Appendix B

Appendix B-1

Information Submitted by SGR/Requested by SEA from SGR

Re: STB Finance Docket 34284, Southwest Gulf Railroad
Company Construction and Operation Exemption – Medina
County, TX – **Request for Information**

Southwest Gulf Railroad Company: Medina County, Texas EXHIBIT 3

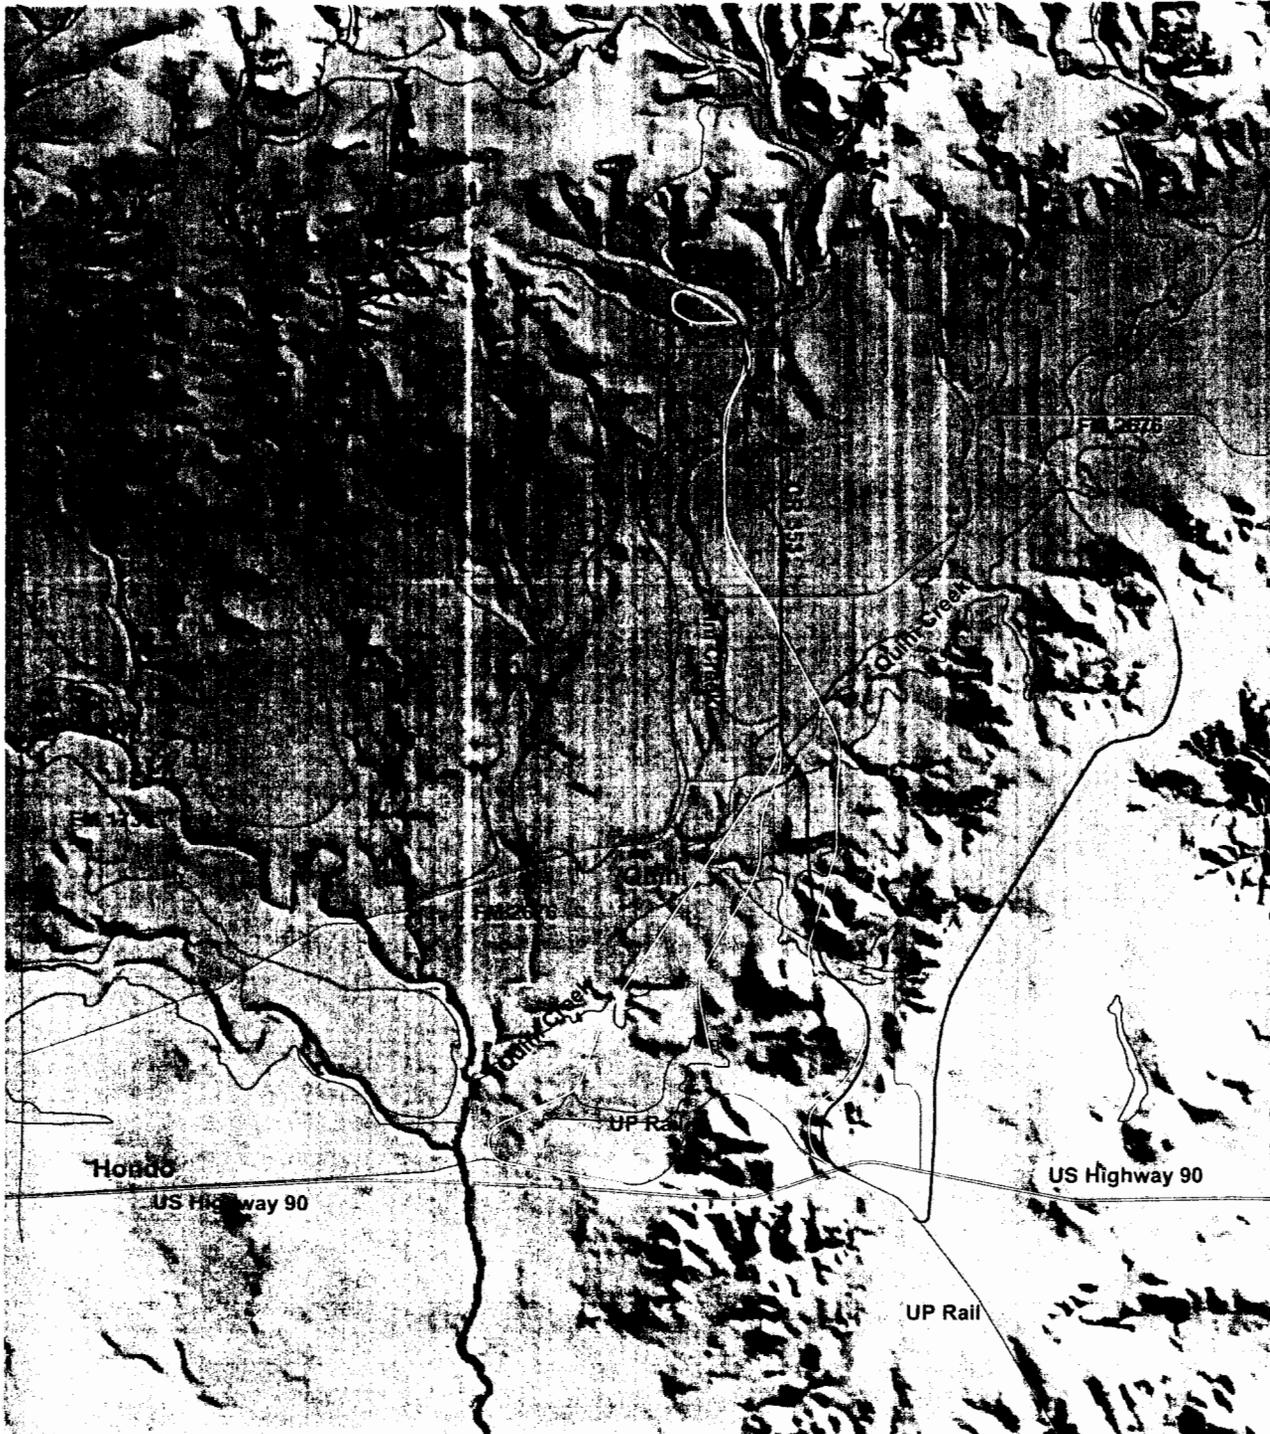
Were the line routed further west of Alternative 1, the floodplain impacts would not diminish. As shown on the map attached to this letter as Exhibit 3, there are significantly more floodplain areas (shown in the light blue lines), and more low-lying areas (shown in blue shade) to the west of the proposed route than in the immediate area of the proposed route or to the east of that area. The floodplain information on this map is drawn from FEMA's Flood Insurance Rate maps, which identify areas of 100 year flood hazard. (Also see page 3-25 of the DEIS, which illustrates the floodplain point addressed here.) In addition, there are larger drainage features west of the current alignment, as is clear from Exhibit 3, as well as Exhibit 5, a satellite photograph of the area. Thus, a westerly bypass would result in surface water impacts that are not present to the same degree with respect to the preferred route, which was designed to cross Quihi Creek at a point designed to minimize impacts. See page 4-37 of the DEIS.
